V2500-D5 SERIES PROPULSION SYSTEM SERVICE BULLETIN

This document transmits Revision 2 to Service Bulletin EV2500-24-0019 and Revision 2 to the Supplement

V2500-ENG-24-0019

ELECTRICAL POWER – VARIABLE SPEED CONSTANT FREQUENCY GENERATOR OIL COOLER –
INTRODUCTION OF REVISED VARIABLE SPEED CONSTANT FREQUENCY (VSCF) GENERATOR COOLING
TUBES

VSCF Generator Cooling Oil Tubes Clipping points
Figure 2 (sheet 1)

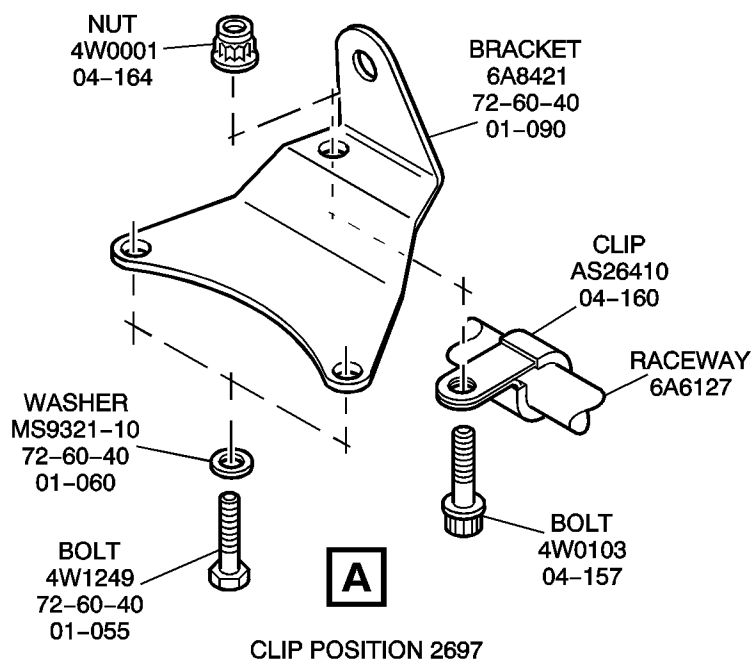
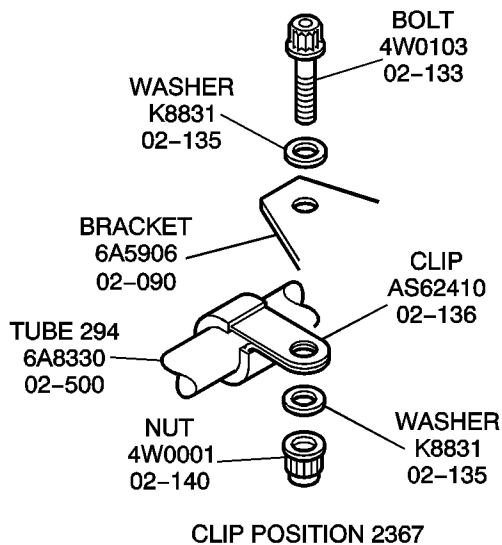
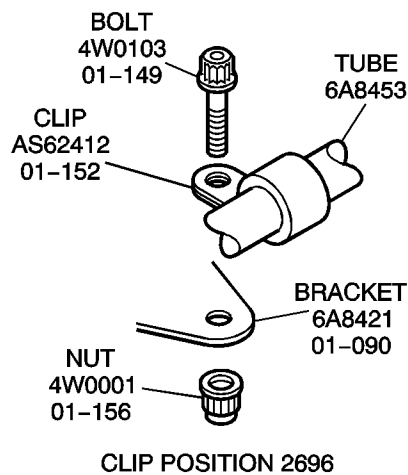
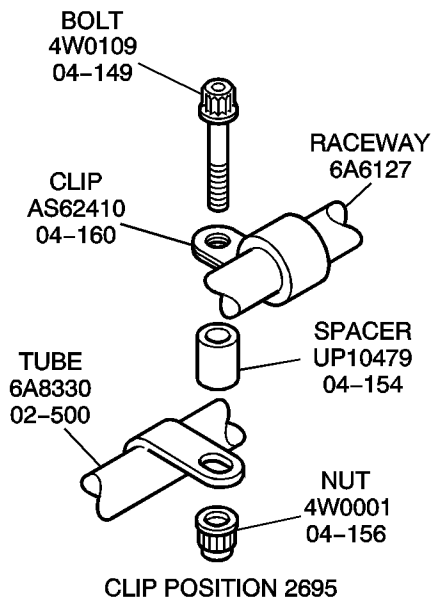
The existing clipping bracket, mounted on the Angle Gearbox housing, has been deleted and replaced with a new bracket attached to the base of the radial gear assembly.

- (b) The existing clipping bracket, mounted on the Angle Gearbox housing, has been deleted and replaced with a new bracket attached to the base of the radial gear assembly.

- (i) Install the bolts 4W1249, the washers MS9321-10 and the bracket 6A8421 to the gearbox, Figure 2 sheet 1. Torque the bolts to 85 to 105 lbfin (10 to 12 Nm).

- (i) At clip position 2367 install the clip AS62410 on the tube 6A8330, the bolt 4W0103, the two washers K8831, and the nut 4W0001, Figure 2 sheet 2. Torque the nut to 36 to 45 lbfin (4 to 5 Nm).
- (ii) At clip position 2695 install the clip AS62410 on the harness raceway 6A6127, the bolt 4W0109, the spacer UP10479 and the nut 4W0001 to the lug on tube 6A8330, Figure 2 sheet 2. Torque the nut to 36 to 45 lbfin (4 to 5 Nm).
- (iii) At clip position 2696 install the clip AS62412 on the tube 6A8453, the bolt 4W0103 and the nut 4W0001 to the bracket 6A8421 on the gearbox, Figure 2 sheet 2. Torque the nut to 36 to 45 lbfin (4 to 5 Nm).
- (iv) At clip position 2697 install the clip AS62410 on the harness raceway 6A6127, the bolt 4W0103 and the nut 4W0001 to the bracket 6A8421 on the gearbox, Figure 2 sheet 1. Torque the nut to 36 to 45 lbfin (4 to 5 Nm).

Schematic View VSCF Cooling Oil System (Before Alteration)
Figure 3

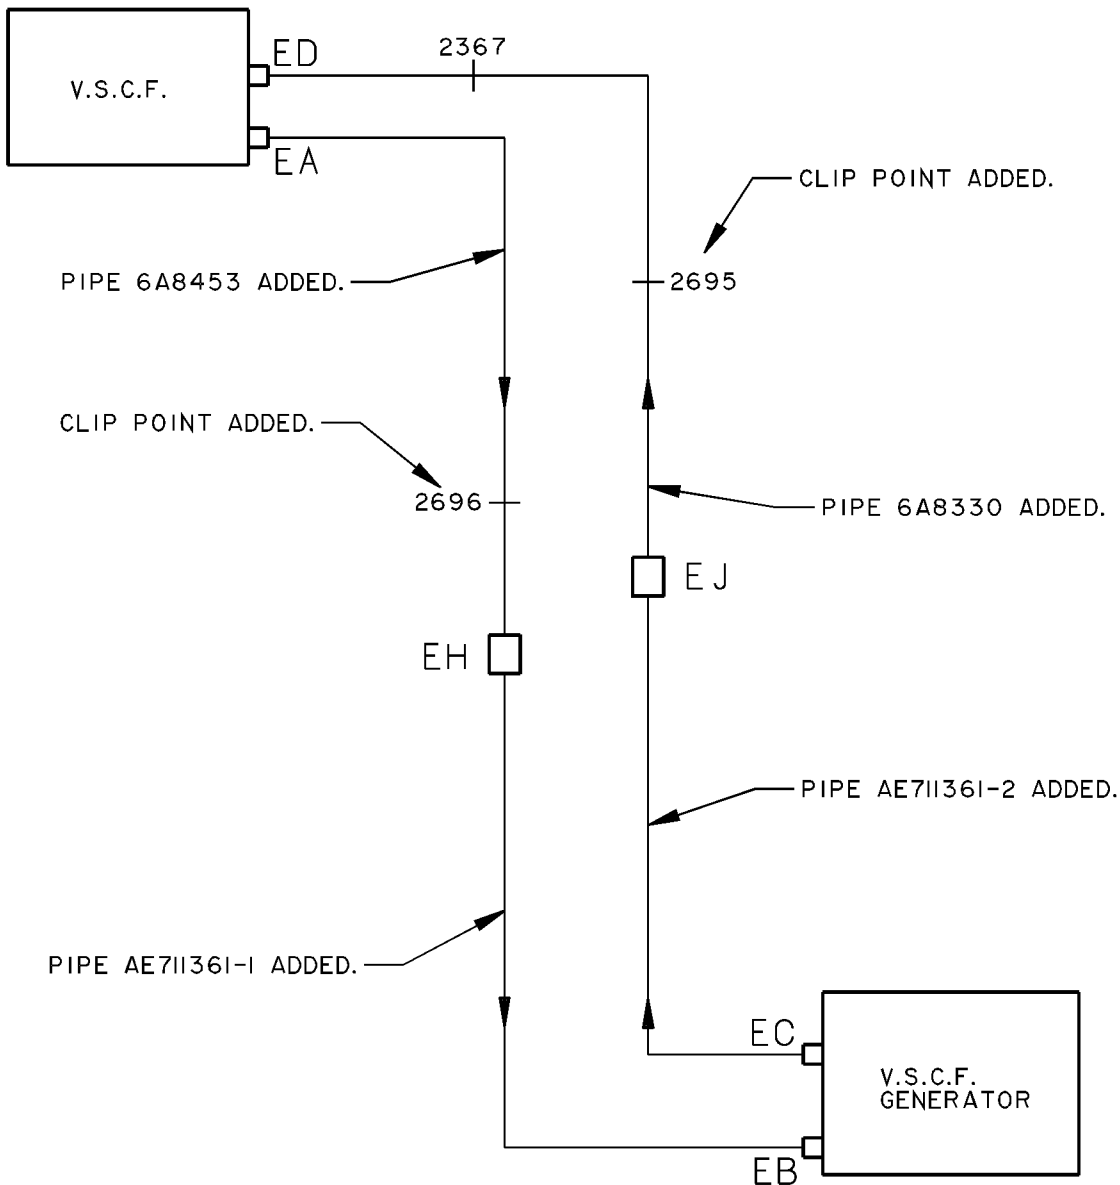
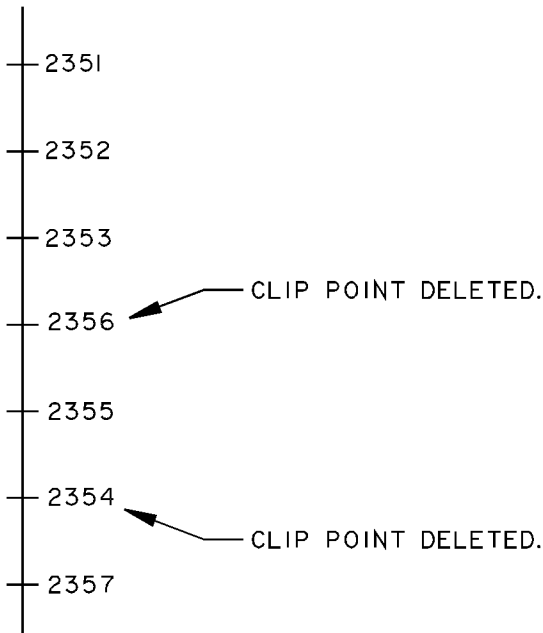
- (a) The existing VSCF to dedicated FCOC and dedicated FCOC to VSCF tubes are revised from one piece assemblies into separate flexible and rigid tube assemblies with the following changes:

- (i) The new flexible section is constructed from a helicoidally convoluted Teflon (PTFE) bore pipe which is surrounded by a wire braid. This is enclosed by a fire resistant silicone sleeve.
- (ii) Disconnects have been introduced between the rigid and flexible pipes.
- (iii) A 90 degree elbow has been introduced adjacent to the disconnect on the oil cooler to VSCF rigid tube assembly.
- (iv) The flexible tube routing has changed to reduce the bend radii.

Schematic View of Raceway (Before and After Alteration)
Figure 5

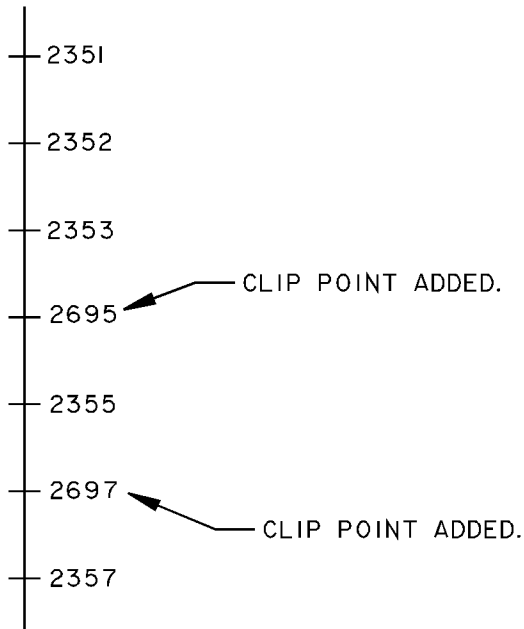
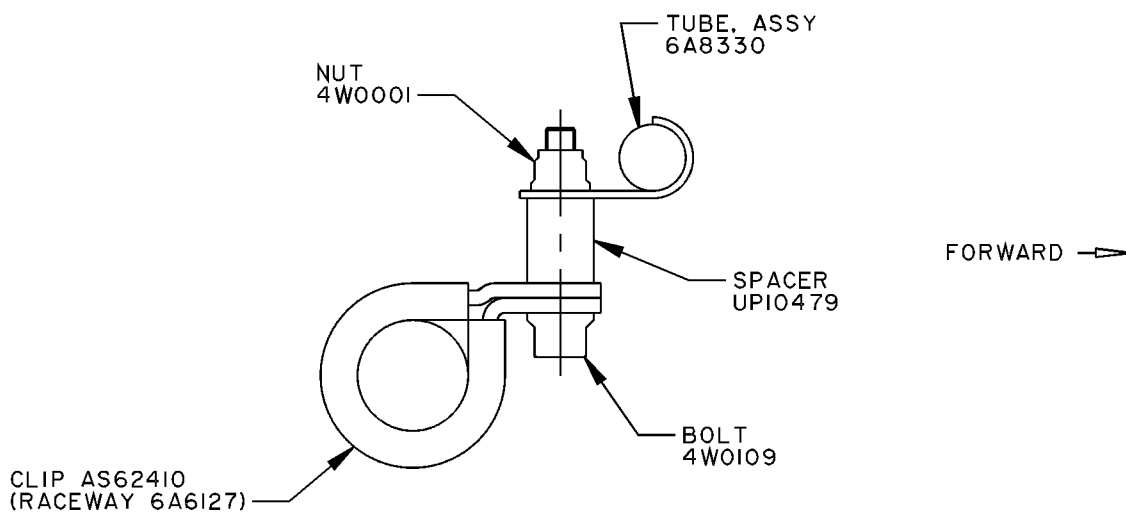
(d) The following clip points are introduced:

CP2695, CP2696, CP2697.

Clip Points 2695 and 2696
Figure 6

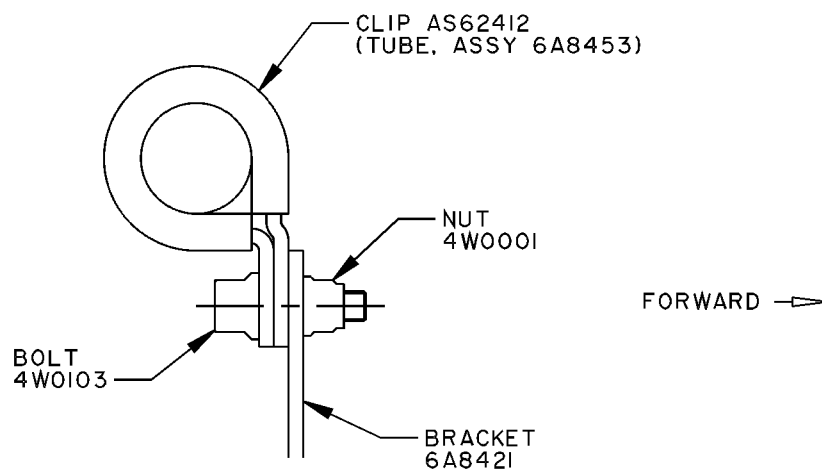
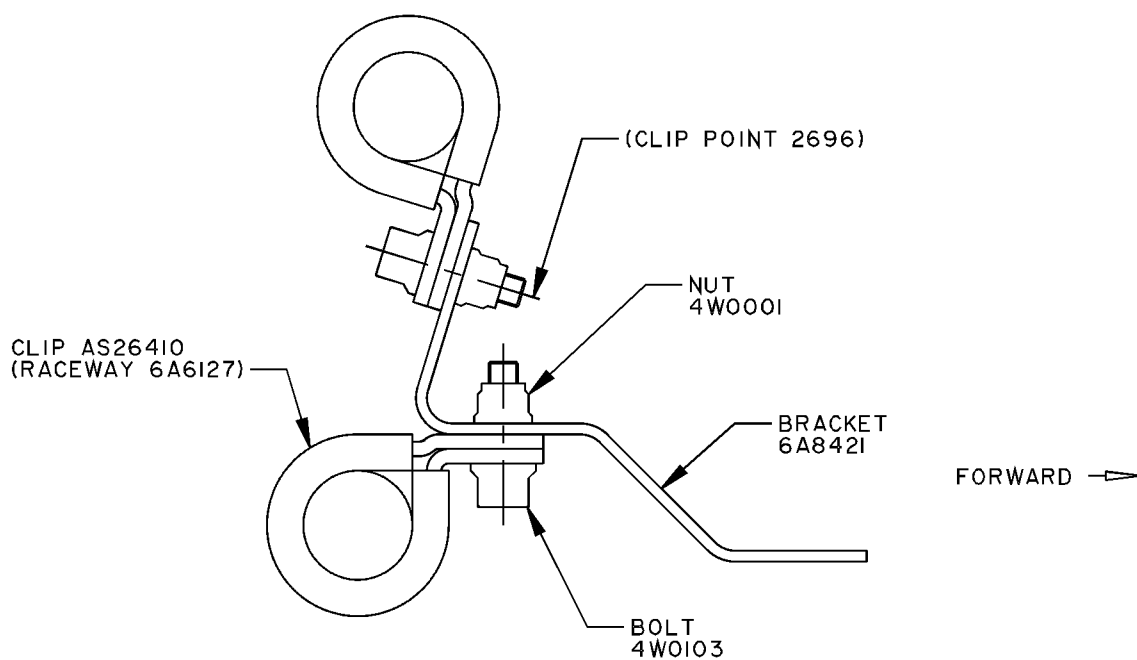
CLIP POINT 2695 ADDED.

CLIP POINT 2696 ADDED.

CLIP POINT 2697 ADDED.
